In the Drawings

REMARKS

VERSION SHOWING CHANGES

FIG. 5

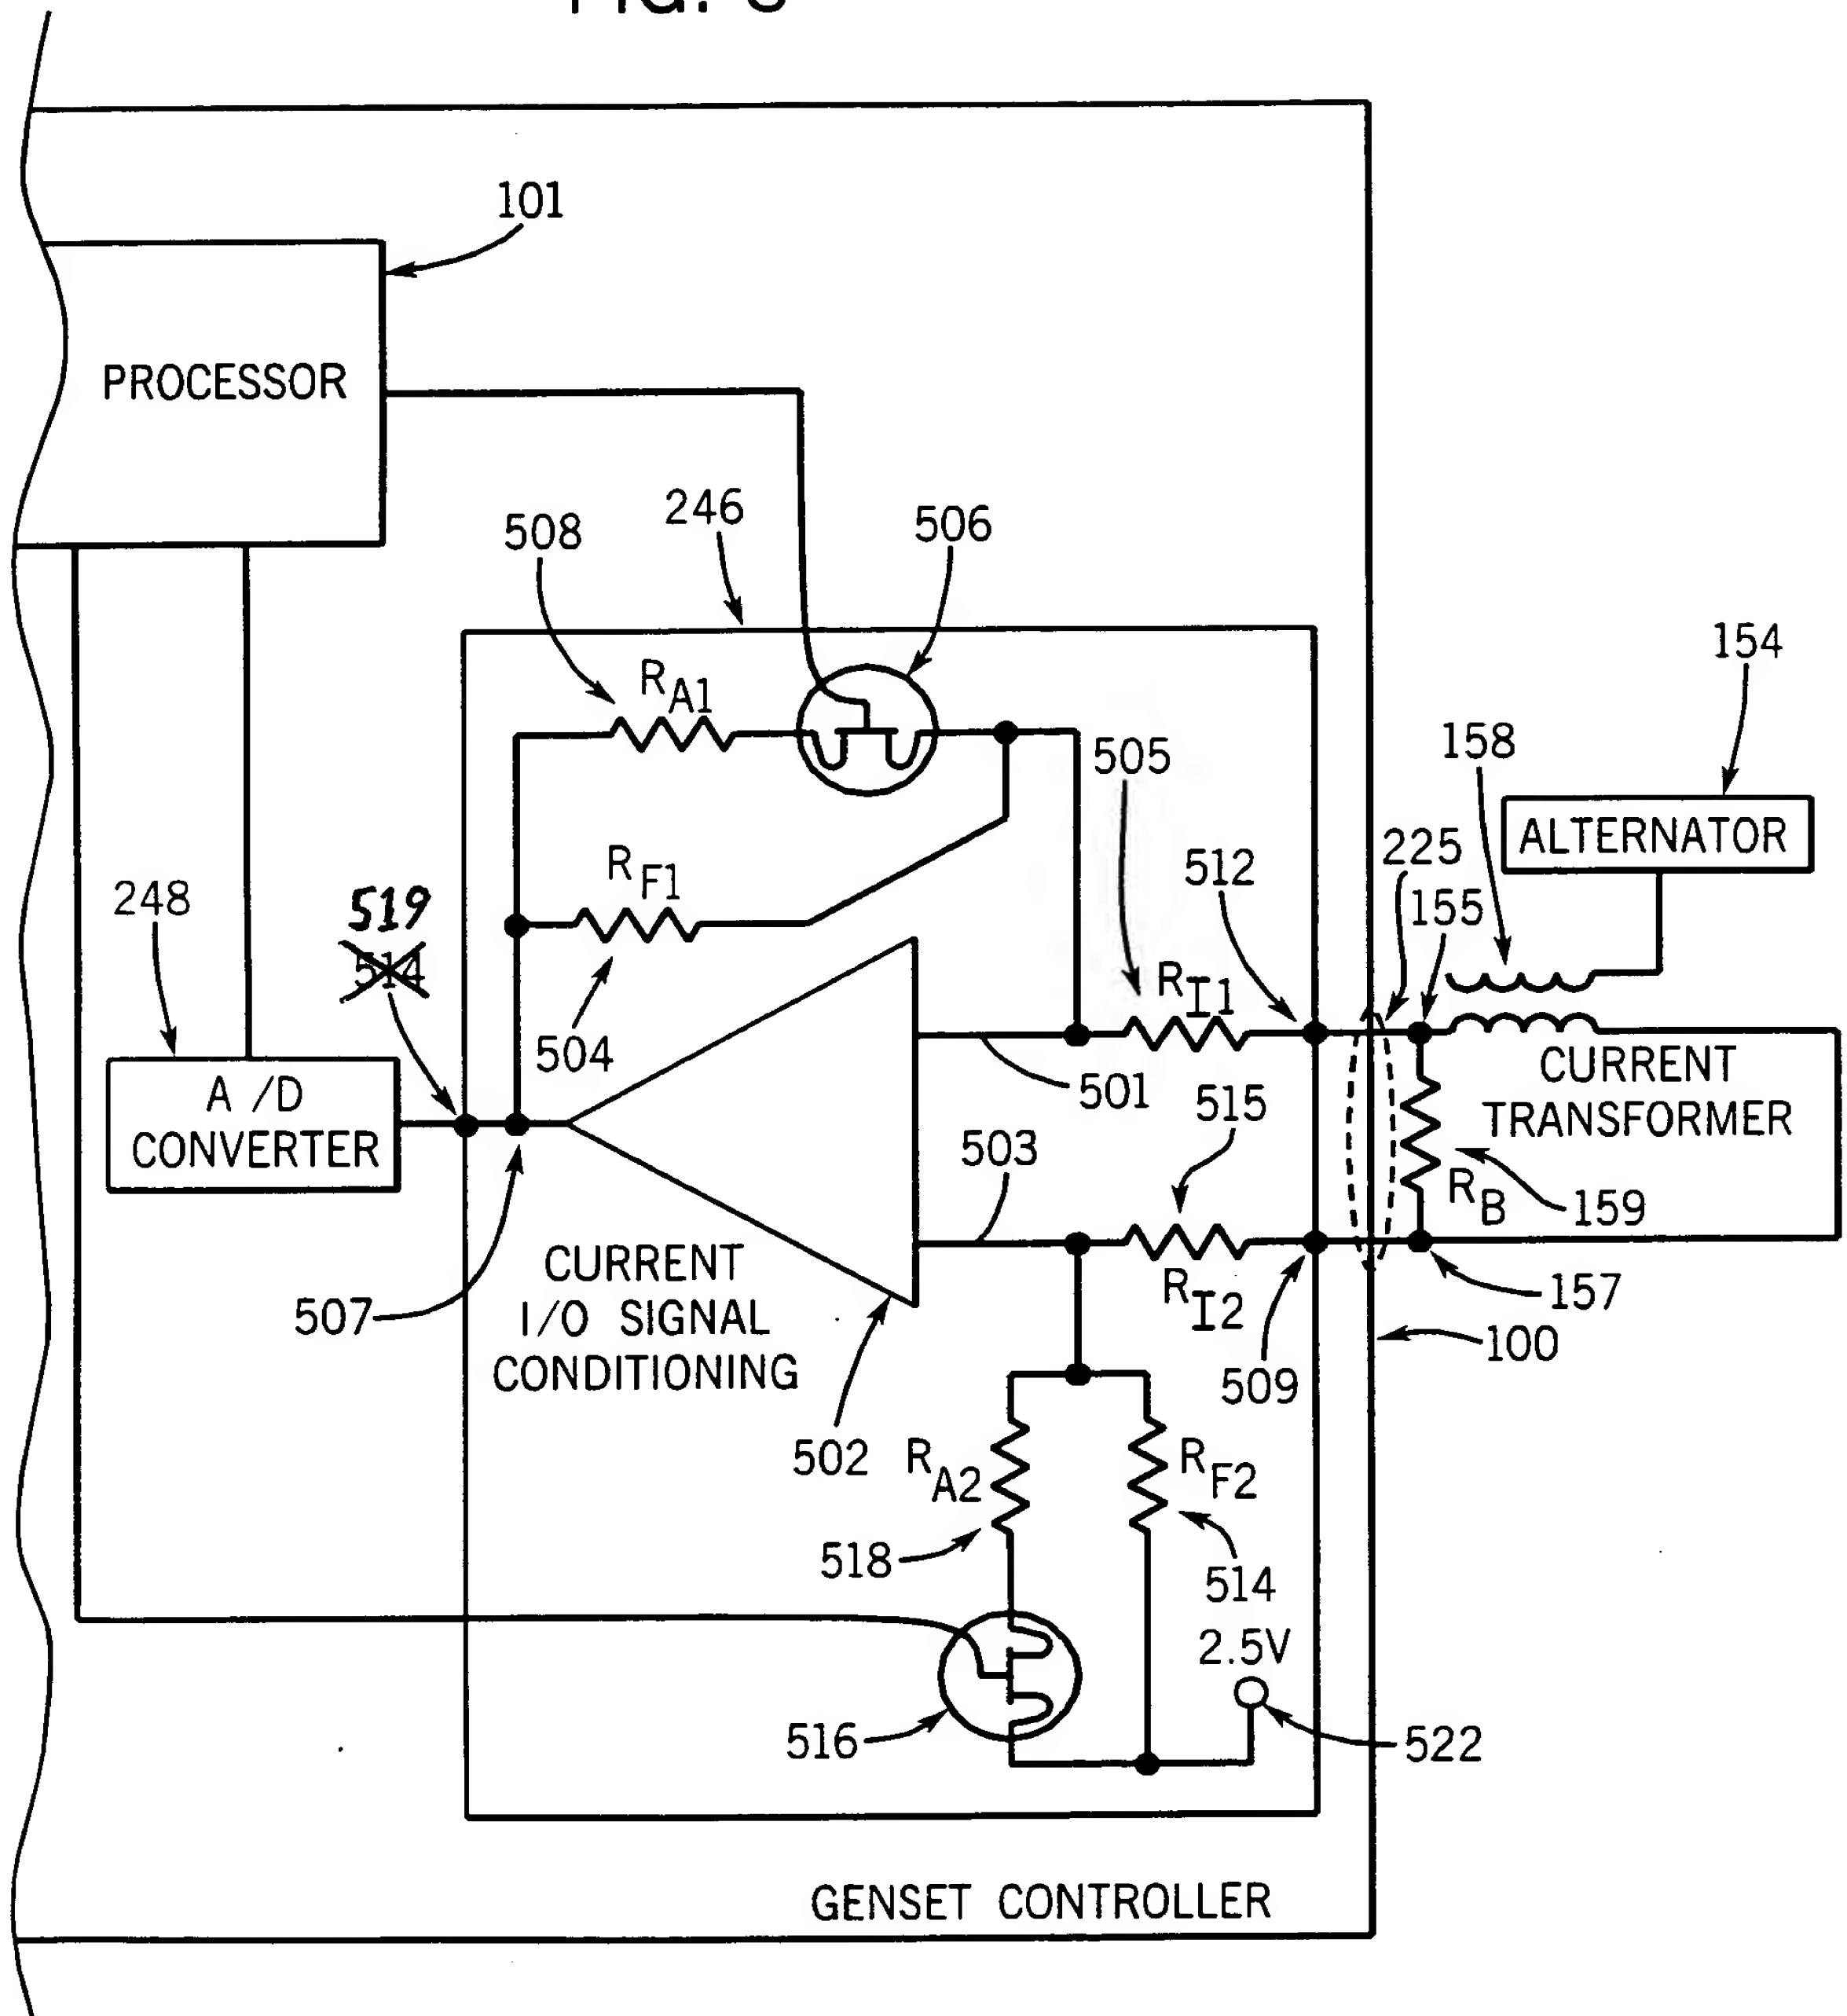
The Applicants appreciate the Examiner's care and attention in reviewing the present Application and in providing comments in the Office Action. In the Office Action, the Examiner indicated that a new title is required that is clearly indicative of the invention to which the claims are directed. Further, the Examiner objected to the drawings because of inconsistent use of the reference character "514" and with respect to claim 10.

The Applicants appreciate the Examiner's observation that the reference character "514" is used both to refer to an output port and a second feedback resistor. To rectify this error, the Applicants have amended Fig. 5 so that the output port is labeled with a new reference character "519" rather than "514". The existing reference character "514" continues to be used to refer to the second feedback resistor. Additionally, three paragraphs in the Specification have been amended to correspond properly to the amended Fig. 5 and to correct a minor typographical error. No new matter has been added by these amendments.

A second input resistor 515 (R_{I2}) is similarly coupled between a second input port 503 of the operational amplifier 502 and a second input port 509 of the current conditioning circuit 246, which is coupled to a second terminal 157 of the current transformer 158 by way of the system current input 225. A burden resistor 159 (R_B) is coupled between the two terminals 155, 157 of the current transformer to provide a return path for current between terminals 155, 157. An output port 507 of the operational amplifier 502 is provided to the analog-to-digital converter 248. The output port 507 is coupled to an [outport] output port [514] 519 of the current conditioning circuit 246.

Without the second feedback and adjustment resistors 514,518 and the second switching element 516, the voltage output at port [514] **519** would tend to zero volts for a zero volt differential applied between ports 512 and 509; however, with the second feedback and adjustment resistors and the second switching element the voltage output is biased to 2.5 Volts. By including the second feedback and adjustment resistors 514,518 and second switching element 516, therefore, the output of the differential amplifier is biased to a point above the noise level, and the analog-to-digital converter 248 can be provided power by way of a single positive power supply, instead of requiring both positive and negative power supplies (to handle positive and negative outputs from the differential amplifier. Use of pairs of feedback, adjustment, and input resistors having the same values allows for balanced operation of the differential amplifier.
